Access Compliance Report

Public Rights-of-Way

(Curb Ramps)

Intersection ID: 11538	Main Street: FREEDOM_DR	Cross Street: BERRYHILL_RD	Location:	N
ADA ID: CFEA118A36BB	Ramp Type: Perp	Initial Pass/Fail: Fail	Overall Compliance: No	Severity Score: 12.5

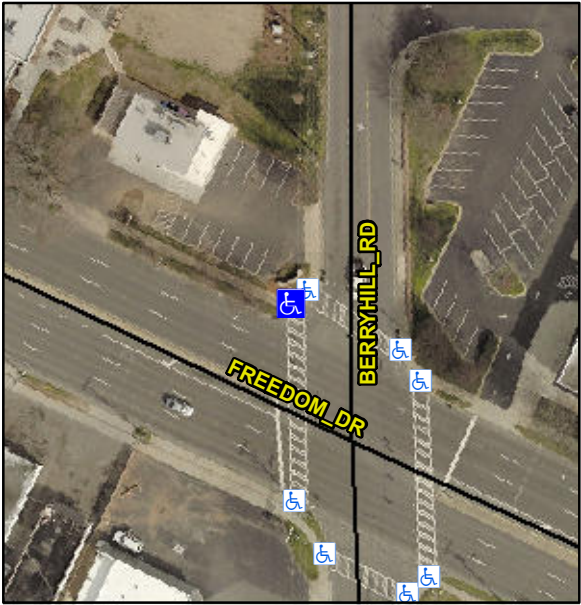
Codes/Mitigation Info/Possible Solution			Field Measurements/Component Compliance		
	Possible Solutions:		Compliance	Description	Data
	Remove & Replace Entire Ramp.		No	Ramp Slope (%)	9.0
			Yes	Ramp Width (in)	0.3
			N/A	Flare Type LT	N/A
			N/A	Flare Slope LT (%)	N/A
			N/A	Flare Traversable LT?	N/A
			N/A	Landing Length (in)	N/A
			N/A	Landing Width (in)	N/A
			N/A	Landing Slope (%)	N/A
			N/A	Landing X Slope (%)	N/A
<p>Surveyor Notes:</p> <p>N/A</p> <p>PROW/ADA:</p> <p>Not Found, R304.2.2</p>			N/A	Flare Type RT	N/A
			N/A	Flare Slope RT (%)	N/A
			N/A	Flare Traversable RT?	N/A
			N/A	DWS Provided?	N/A
			N/A	DWS Contrast?	N/A
			N/A	DWS Length (in)	N/A
			N/A	DWS Full Width?	N/A
			N/A	DWS Offset (in)	N/A
			N/A	Gutter Ponding?	N/A
			N/A	Gutter Lip Ht (in)	N/A
			Yes	Painted X Walk1?	N/A
			To S	X Walk 2 Direction	N/A
			N/A	X Walk 2 Width (in)	N/A

0.7	X Walk 2 Slope (%)	N/A
			0.2	X Walk 2 X Slope (%)	N/A
			N/A	Ramp inside XWalk1?	N/A
			N/A	Ramp inside XWalk2?	N/A
			N/A	Clear Space?	N/A
			N/A	Clear Space to XWalk (in)	N/A
			N/A	Storm Grate/Utility Hazard?	N/A
			N/A	Obstruction Type	N/A
			N/A	Surface Condition? (G/P)	Good
